Applicant : Nikolai N. Issaev
Serial No. : 10/719,014
Filed : November 24, 2003
Page : 11 of 15

Attorney's Docket No.: 08935-291001 / M-5027/Z-
03494

Amendments to the Drawings:

Page 2 of 2
Appl. No.: 10/719,014
Amendment in Reply to Office action of January 8, 2007
Annotated Sheet Showing Change(s)

FIG. 2

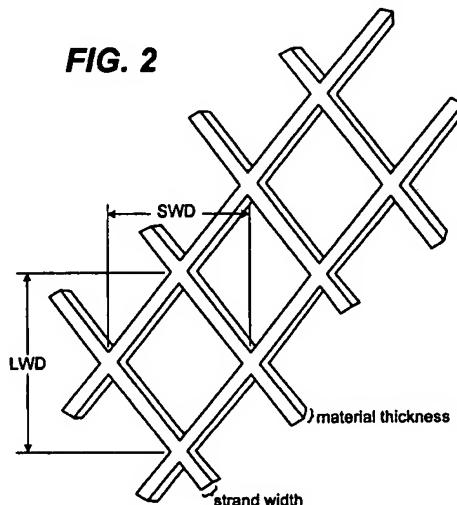
The attached replacement sheet of drawing includes changes to Fig. 2 and replaces the original sheet including Fig. 2.

In Figure 2, the metal grid drawing was extended to show an array of diamond-shaped openings.

Applicants amended the specification to state that the grid shown in Figure 2 includes an array of diamond-shaped openings. Support for the amendment to the specification can be found in Figure 2, which shows a grid with an array of diamond-shaped openings.
